OAKDEN ESTATES SUBDIVISION

APPLICATION NUMBER 23 DATE October 16, 2008

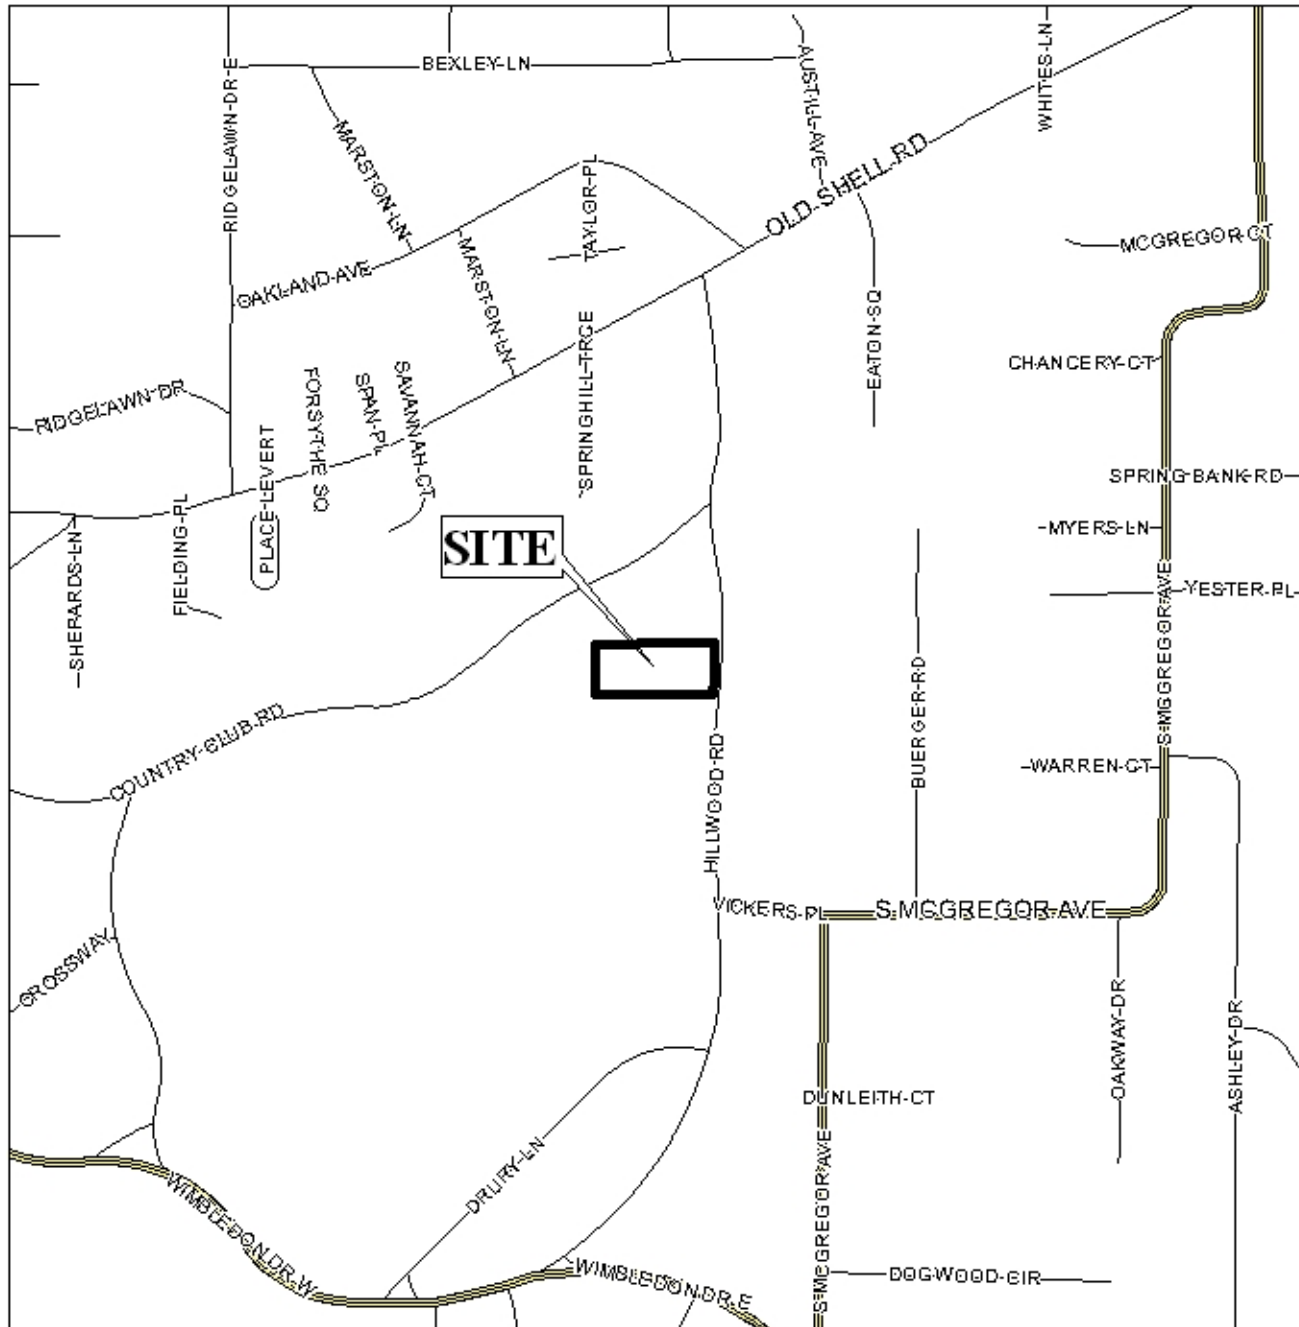
The proposed subdivision has frontage on Hillwood Road with a compliant 50' right-of-way; therefore, no dedication is required. The plat illustrates the 25' minimum building setback line along Hillwood Road for Lots 2 and 3, and along the East portion of Lot 3, and this should also be shown on the final plat. As a means of access management, a note should be required on the final plat stating that each lot is limited to one curb cut to Hillwood Road, with the size, location, and design to be approved by Traffic Engineering and conform to AASHTO standards.

Each lot is labeled on the plat with its size in acres and square feet, and should also be so-labeled on the final plat, or a table should be provided furnishing the same information.

The site contains an existing dwelling, but a note on the plat indicates that it is to be removed. The residence must be removed, with the proper building demolition permit, prior to the signing of the final plat.

- 1) illustration of the 25' minimum building setback line along Hillwood Road for Lots 2 and 3, and along the East line of Lot 1;
- 2) placement of a note on the final plat stating that each lot is limited to one curb cut to Hillwood Road, with the size, location, and design to be approved by Traffic Engineering and conform to AASHTO standards;

- 3) labeling of each lot with its size in acres and square feet, or the provision of a table on the plat furnishing the same information;
- 4) removal of the dwelling on the site, with proper building demolition permit, prior to signing the final plat;
